**CITY OF PORTLAND, MAINE  
DEVELOPMENT REVIEW APPLICATION  
PLANNING DEPARTMENT PROCESSING FORM  
DRC Copy**

425 Forest Avenue

**Subject: 425 Forest Avenue  
Wendell M. Fletcher**

**COVER LETTER FOR SITE PLAN  
for 425 Forest Ave., Portland, ME 04061**

# SITE PLAN 2005-0126

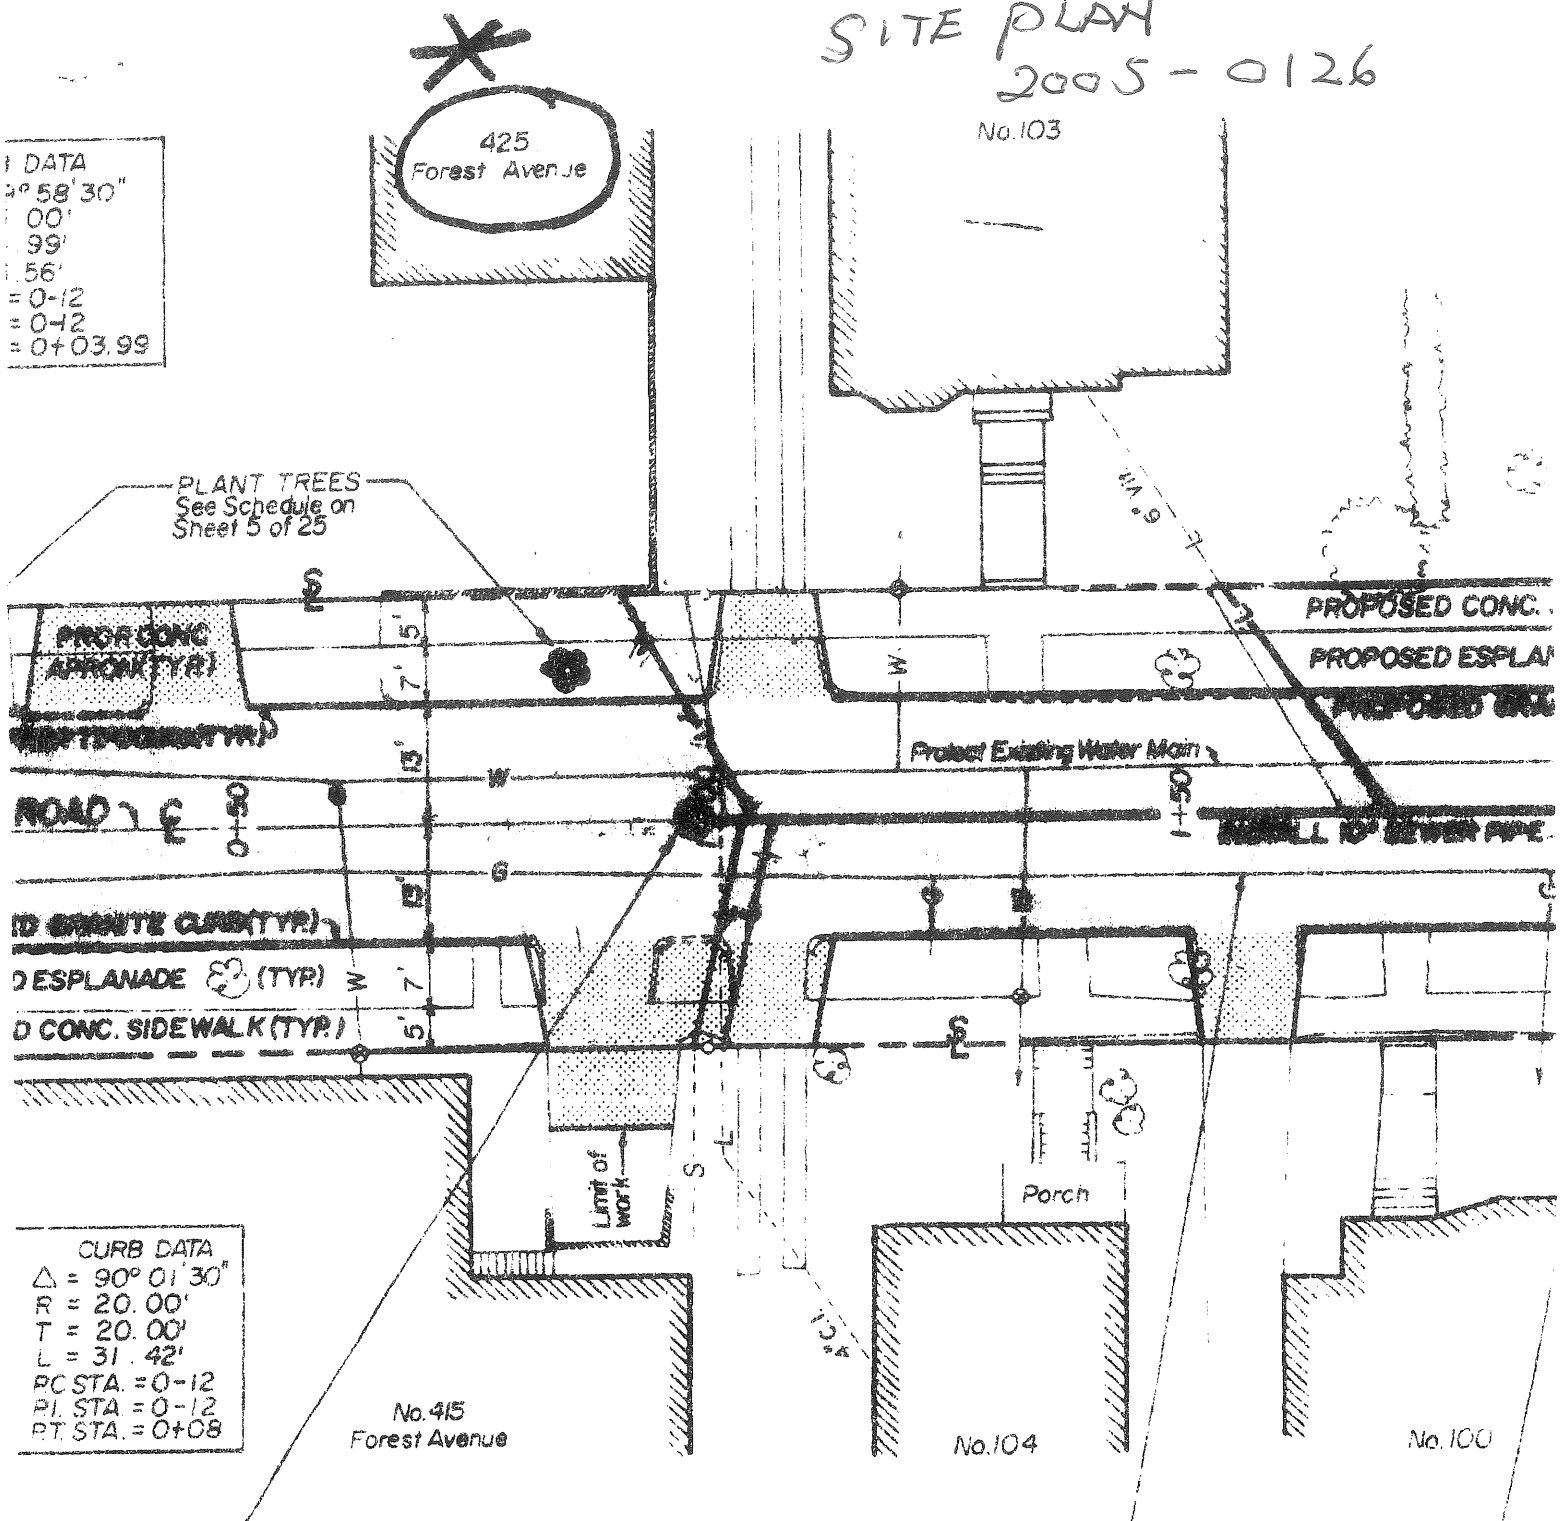
This letter is to request that the dumpster indicated on the Site Plan, be moved from the South side (Deerfield Rd) to the North side, near the existing Burger King dumpster.
